Service Bulletin

FLIGHT CONTROLS - FLAP STRUCTURE MODIFICATION

SB 31-27-35
Recommended
Page 1 of 42

LEARJET 31 Service Bulletin

Inboard Flap Track Roller Fitting, Flap Roller Rib, and Nose Roller Support Rib Replacement
Figure 1 (Sheet 1 of 4)

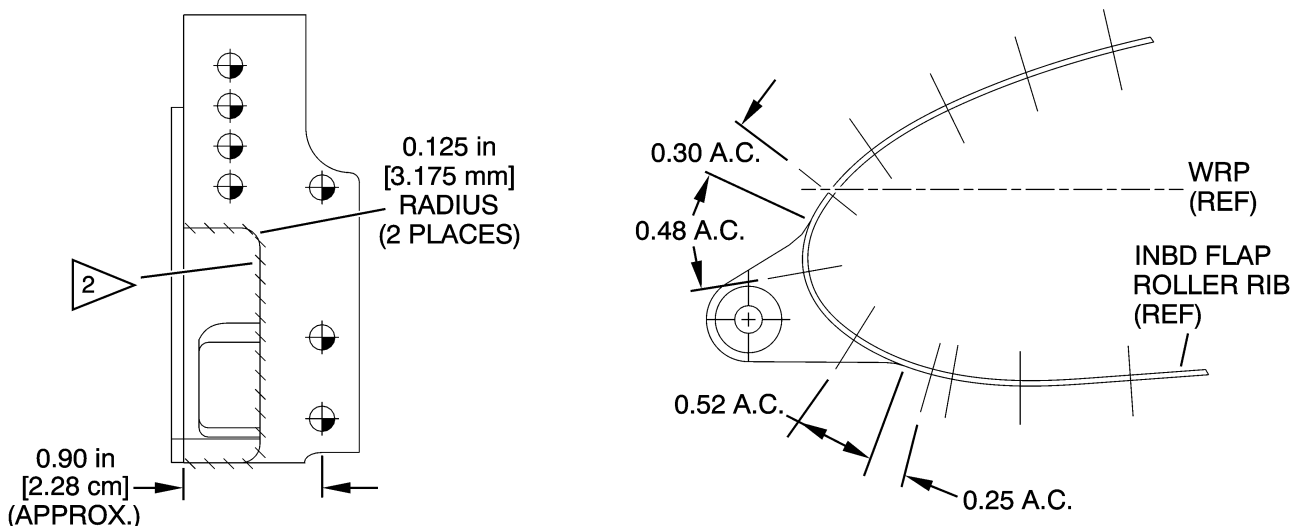
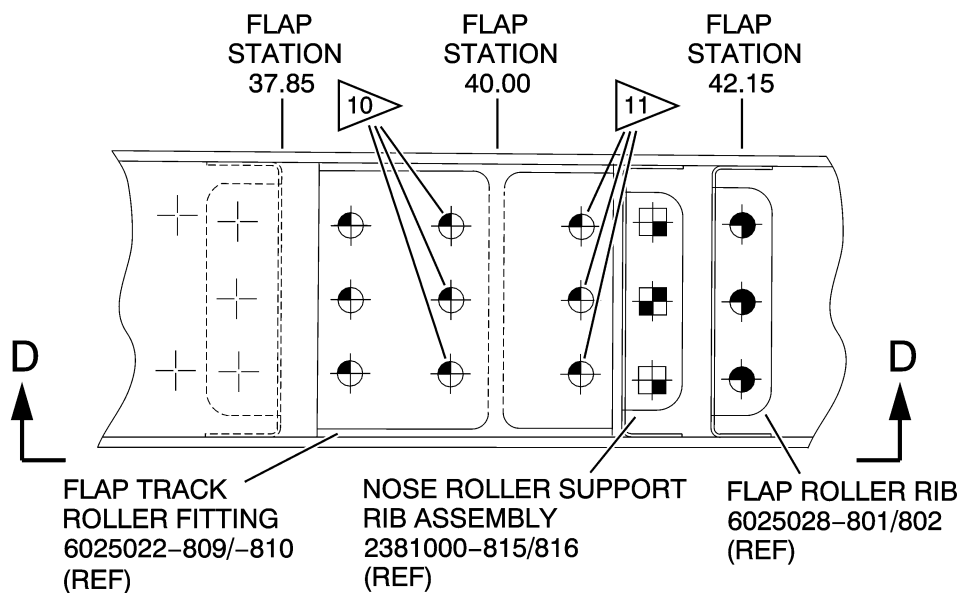
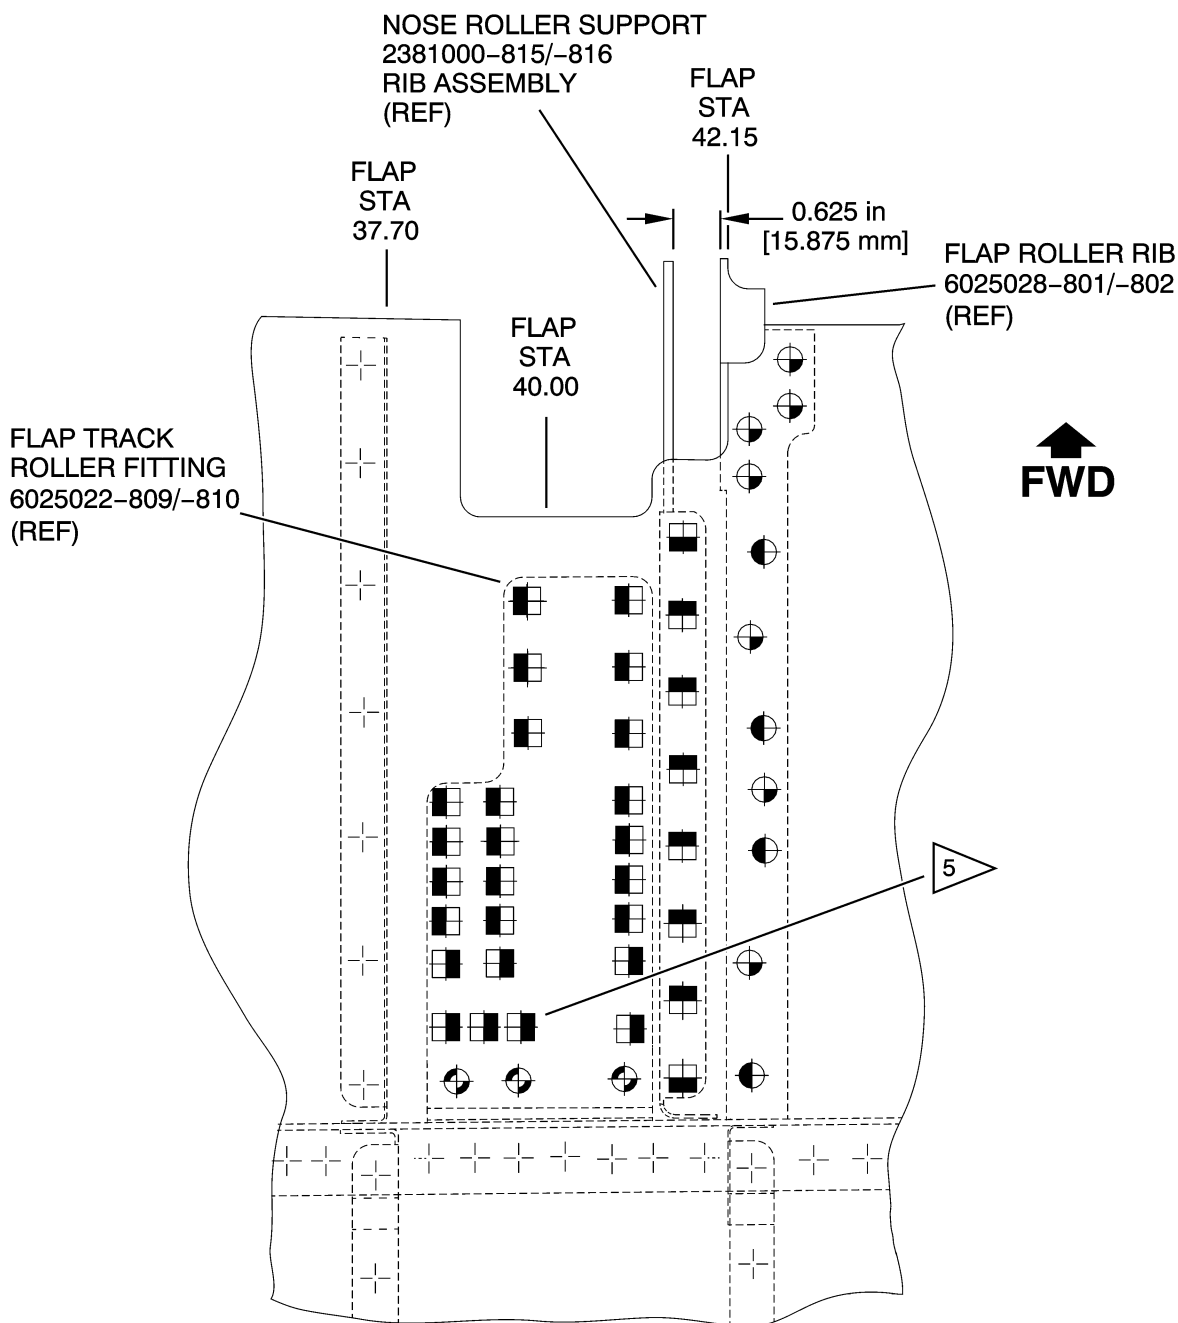
- (5) *On aircraft that have **not** modified the inboard flap roller ribs and the inboard nose roller support rib assemblies in accordance with Service Bulletin 31-27-20, as stated in Step 3.B.(1), install the -820 (LH) and/or -821 (RH) kits as follows: (See [Figure 1](#).) The nose roller support rib assemblies and the flap roller ribs must be replaced together. Both the LH and RH locations must contain all the modified components required.*

- (a) Drill out rivets, as required, to allow the lower trailing edge skins to be peeled back to gain access to the spars and the rib attaching rivets. (Refer to [Chapter 51 of the Structural Repair Manual](#).) (See [Figure 4](#) for approximate rivet locations.)

- (b) Trim the leading edge skins to provide clearance for the replacement nose roller support rib assemblies. (See [Figure 1](#).)
 - (c) Maintain proper minimum edge distance for all rivets when trimming the leading edge skin cut-outs. (Refer to [Chapter 51 of the Structural Repair Manual](#), Section 51-40-02, paragraph 1.D.(1).)

- (g) Install the flap roller ribs and the nose roller support ribs with the new rivets supplied in conjunction with the adhesive bonding method as follows: (See [Figure 1](#).)

- (a) Drill out rivets and remove the flap track roller fittings. (See [Figure 1.](#)) (Refer to [Chapter 51 of the Structural Repair Manual.](#))
- (b) Prefit the new flap track roller fittings to the flap assemblies and match drill to existing holes in skin and structure.
- (c) Apply chemical film and epoxy primer to bare areas. (Refer to [Chapter 20 of the Maintenance Manual.](#))
- (d) Solvent clean mating surfaces. (Refer to [Chapter 20 of the Maintenance Manual.](#))

- (e) Install the inboard flap track roller fittings with the new rivets supplied in conjunction with the adhesive bonding method as follows: (See [Figure 1.](#))

Outboard Flap Track Roller Fitting, Flap Roller Rib, and Nose Roller Support Rib Replacement
Figure 2 (Sheet 1 of 4)

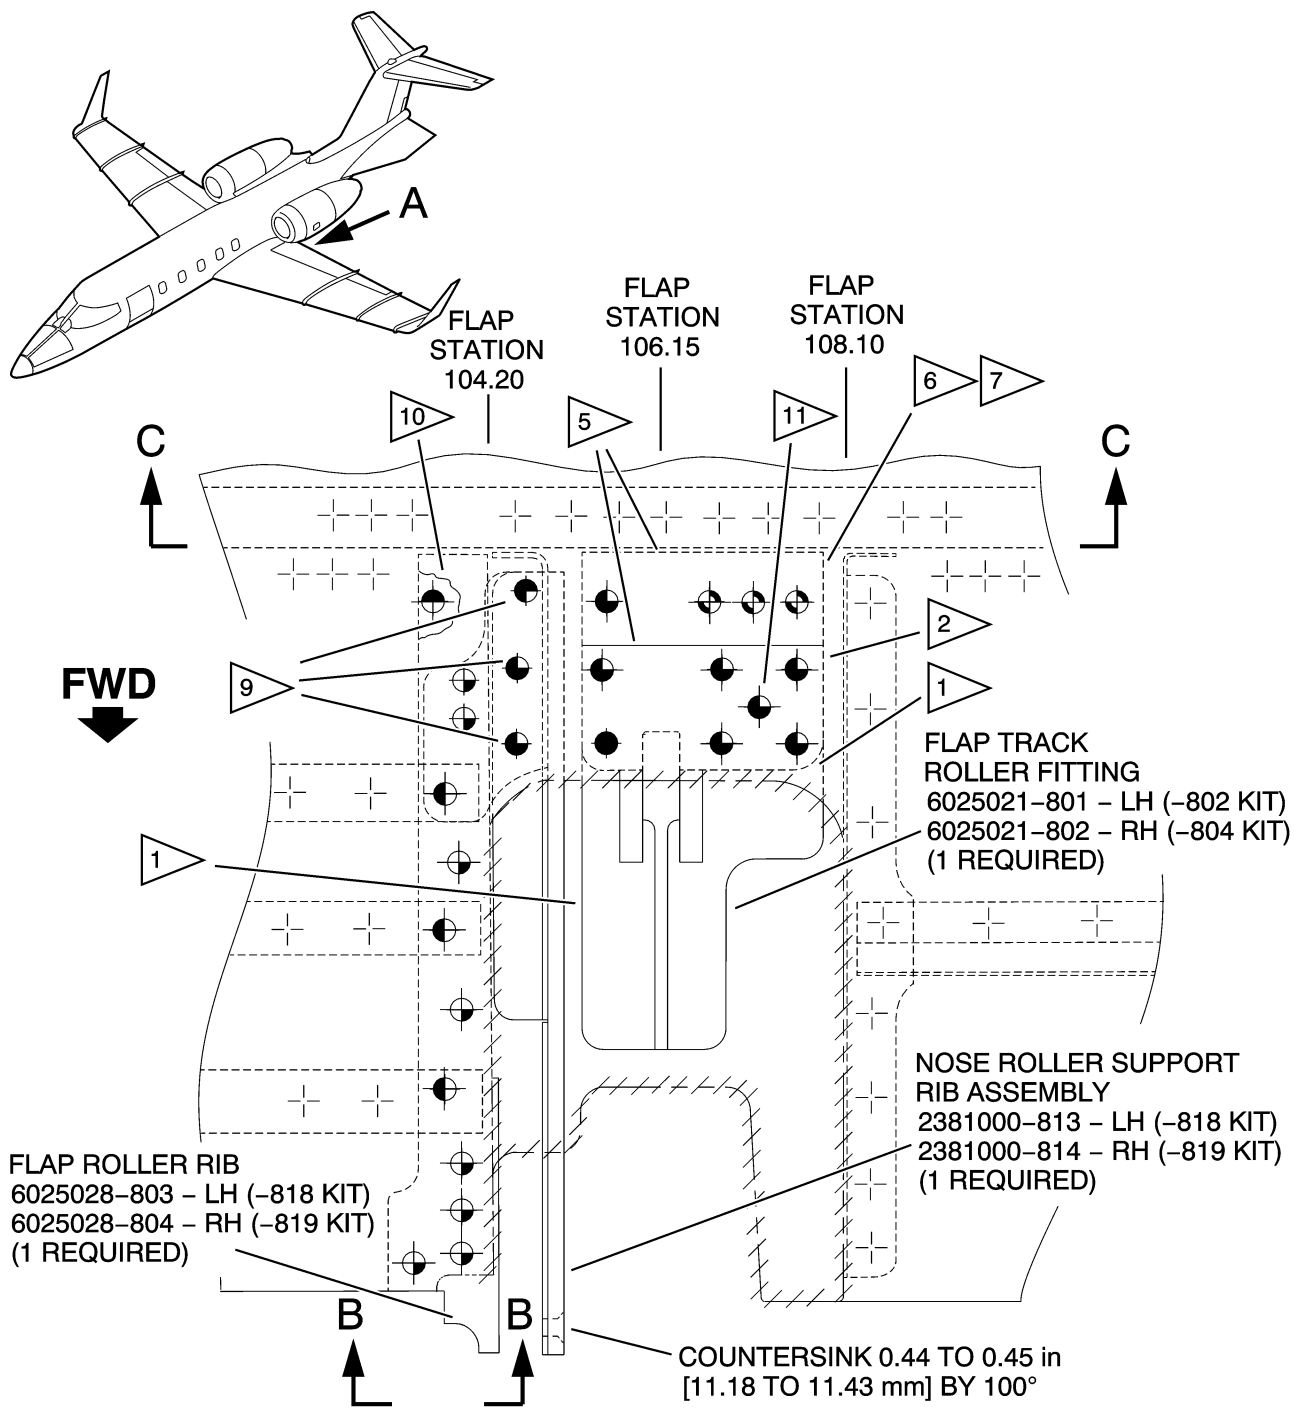
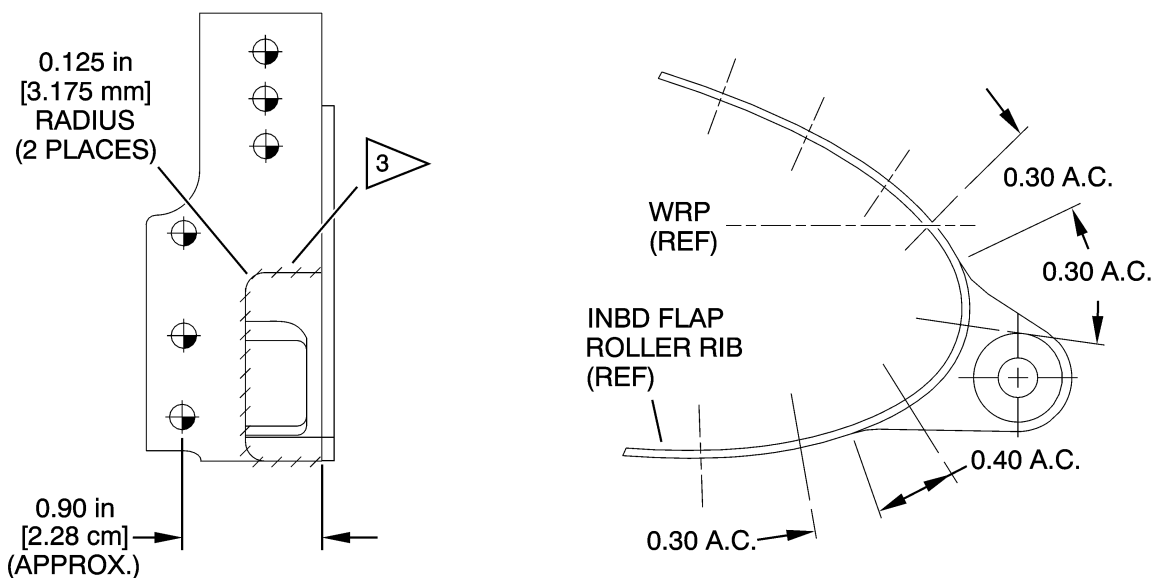
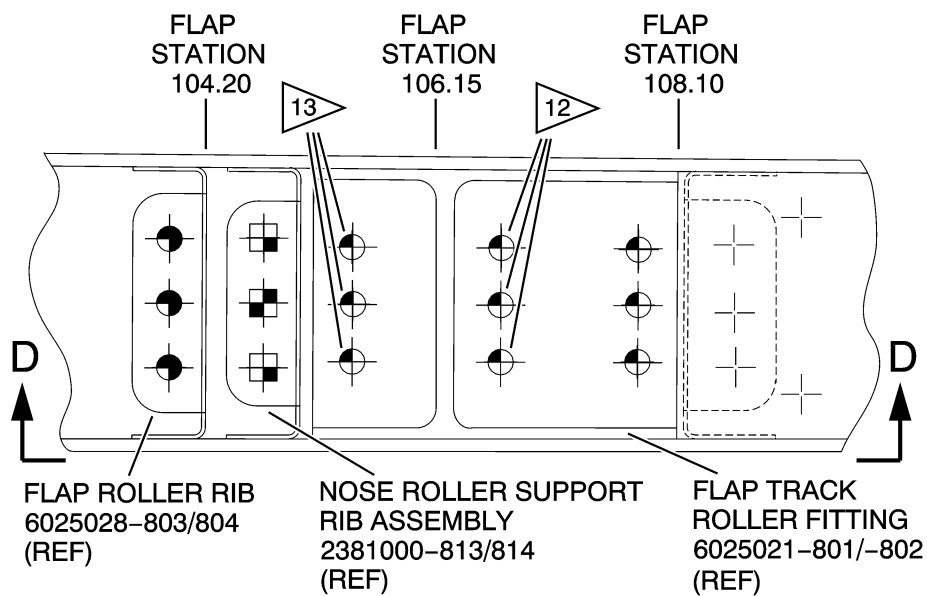
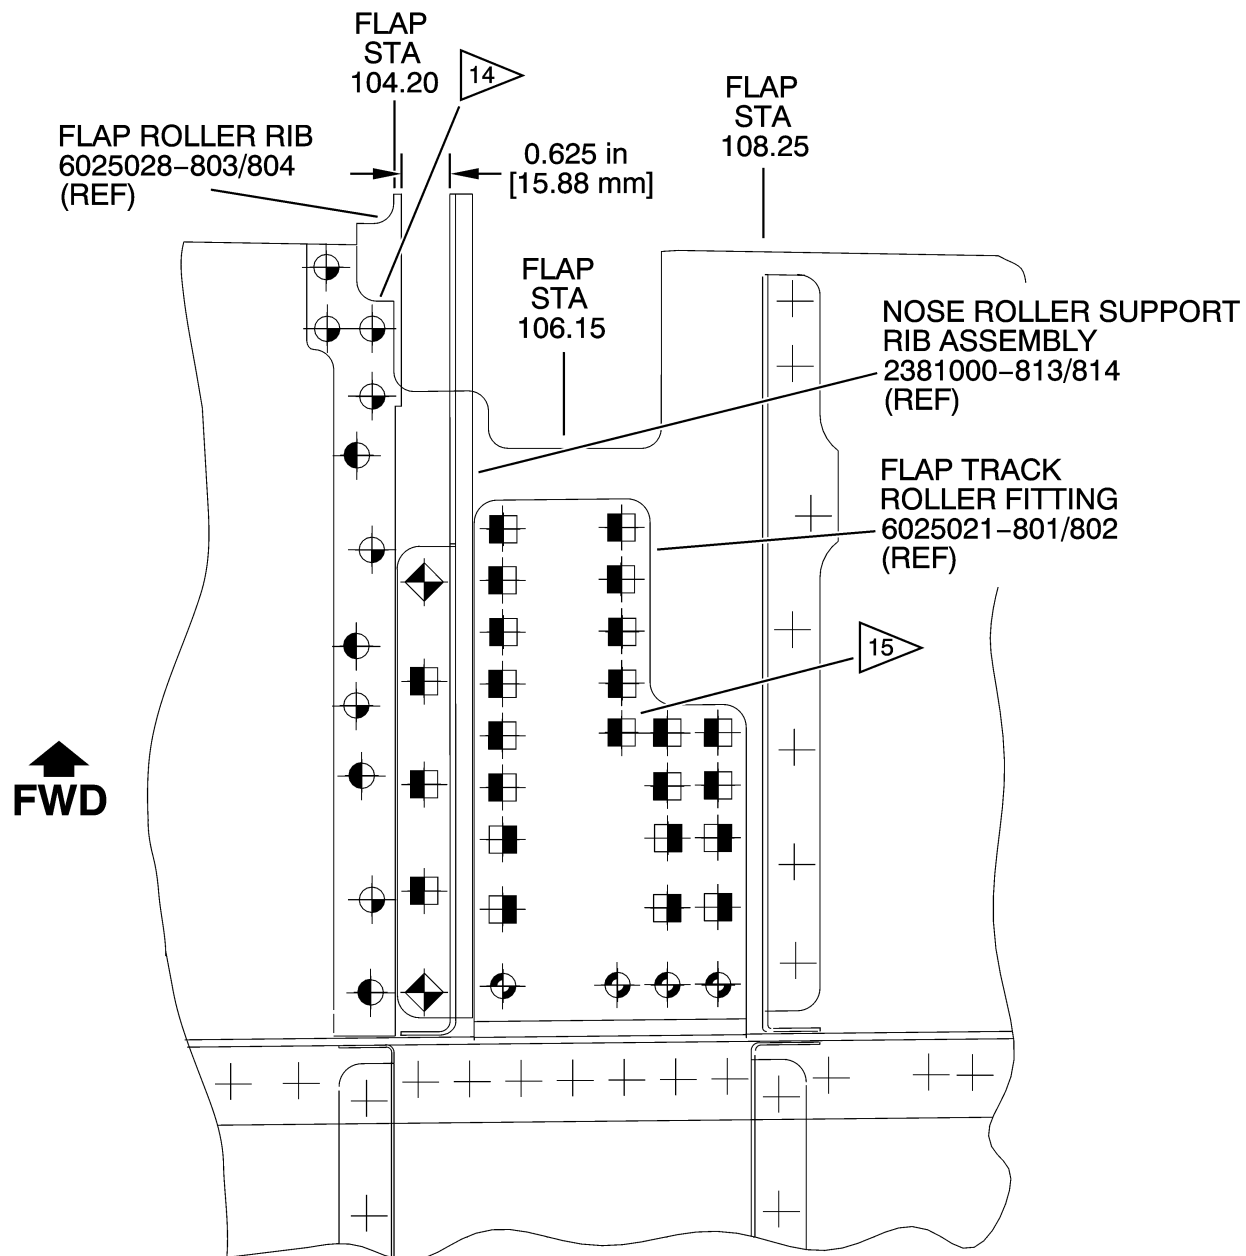
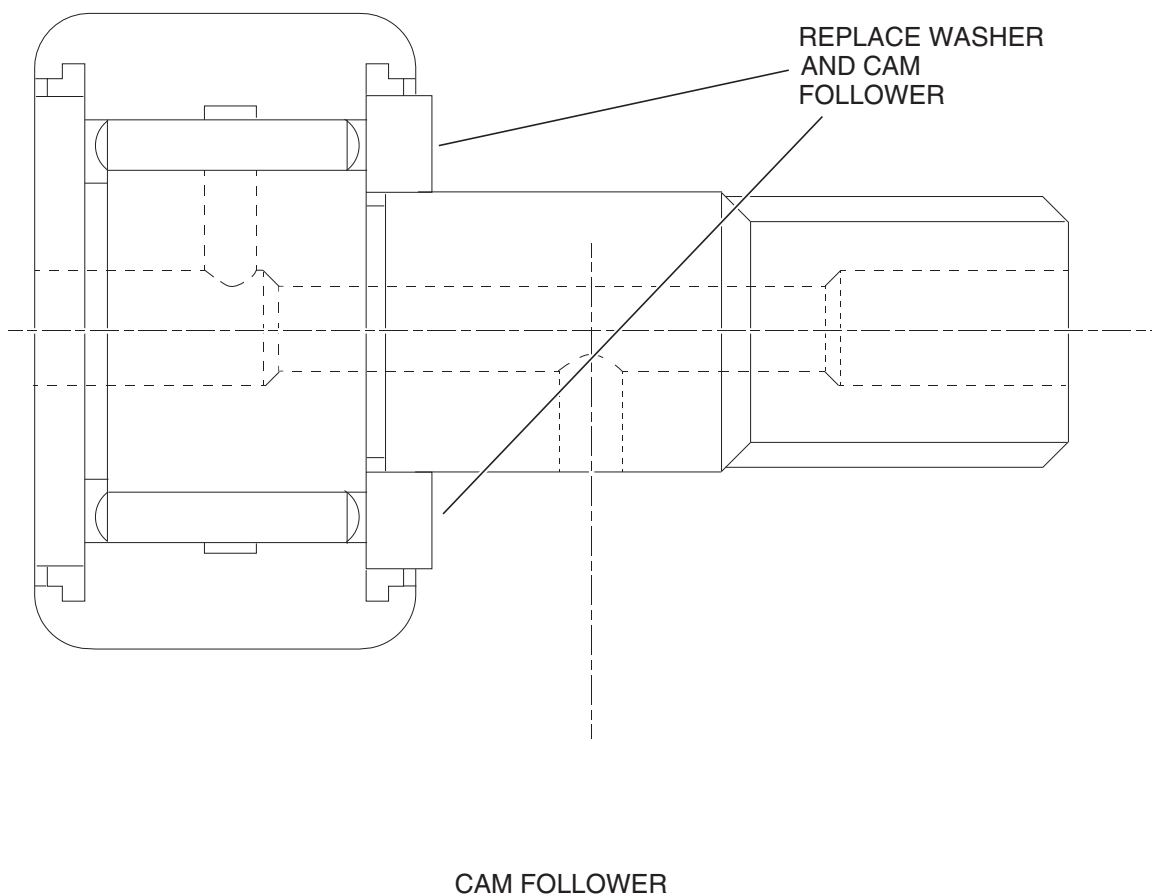
- (7) On aircraft that have **not** modified the outboard flap roller ribs and the outboard nose roller support rib assemblies in accordance with Service Bulletin 31-27-20, as stated in the Step 3.B.(1) of this document, install the -818 (LH) and/or -819 (RH) kits as follows: (See [Figure 2](#).) The nose roller support rib assemblies and the flap roller ribs must be replaced together. Both the LH and RH locations must contain all the modified components required.

- (b) Trim the leading edge skin to provide clearance for the replacement nose roller support rib assembly. (See [Figure 2](#).)
 - (c) Maintain proper minimum edge distance for all rivets when trimming the leading edge skin cut-outs. (Refer to [Chapter 51 of the Structural Repair Manual](#), Section 51-40-02, paragraph 1.D.(1).)

- (g) Install the flap roller ribs and the nose roller support ribs with the new rivets supplied in conjunction with the adhesive bonding method as follows: (See [Figure 2](#).)

- (a) Drill out rivets and remove the flap track roller fittings. (See [Figure 2.](#)) (Refer to [Chapter 51 of the Structural Repair Manual.](#))
- (b) Prefit the new flap track roller fittings to the flap assemblies and match drill to existing holes in skin and structure.
- (c) Apply chemical film and epoxy primer to bare areas. (Refer to [Chapter 20 of the Maintenance Manual.](#))
- (d) Solvent clean mating surfaces. (Refer to [Chapter 20 of the Maintenance Manual.](#))

- (e) Install the outboard flap track roller fittings with the new rivets supplied in conjunction with the adhesive bonding method as follows: (See [Figure 2.](#))
